Water Licence 1BR-RES0916 Amendment Application June 2010

Application Deficiencies Response

Executive Summary of Water Licence 1BR-RES0916 Application Amendment

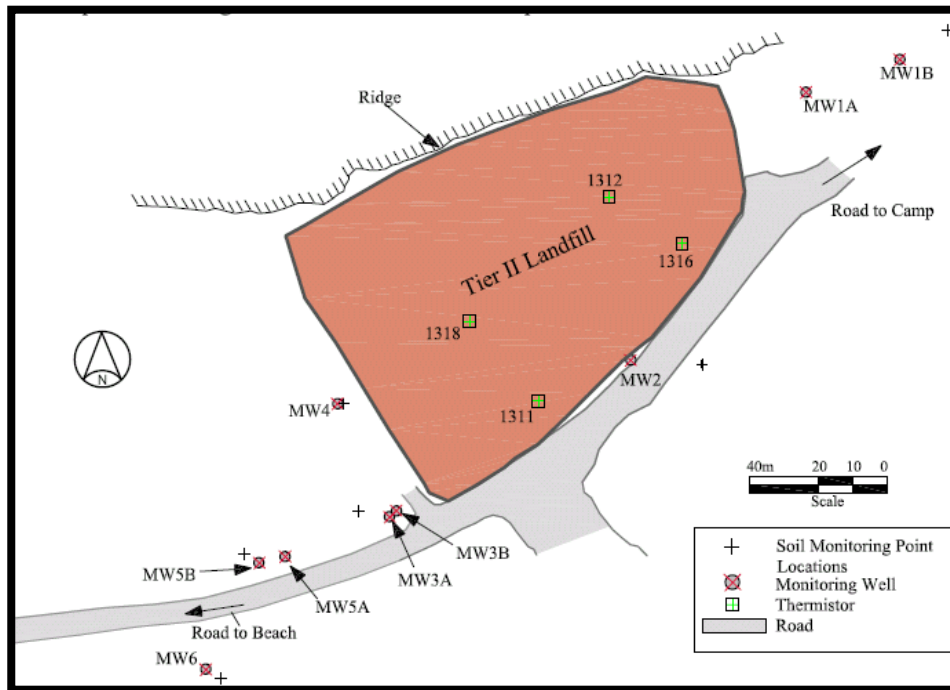
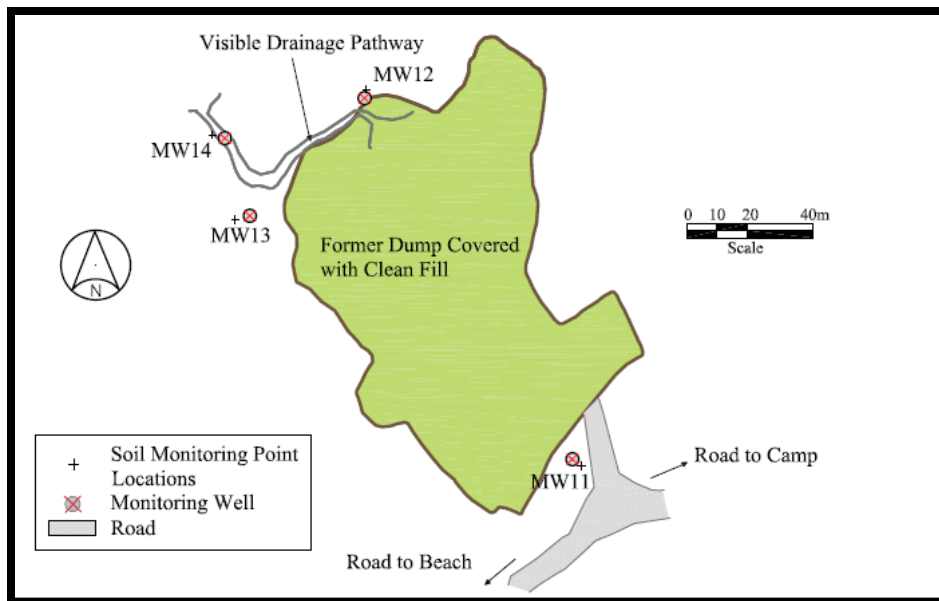
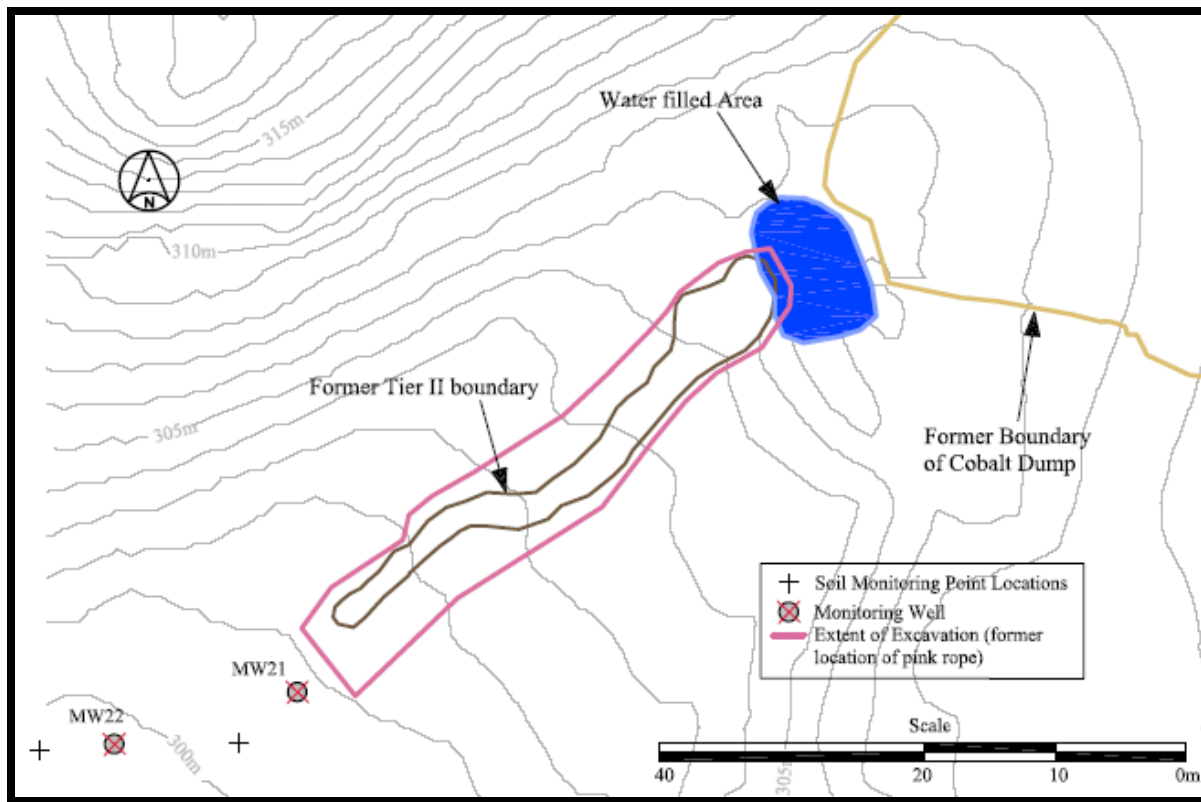
Item D11: “Even though the 2005 review mentioned that the locations for the monitoring points are to be verified against as-built drawings, EC recommends specifically that the maps of the sampling locations be included in an appendix. These maps should indicate photograph locations and the direction for all visual sampling locations.”

Response D11: Please see Appendix C of this submission for sample point locations and maps and associated GPS co-ordinates. As part of the five year review a systematic photographic record will be taken and reported.
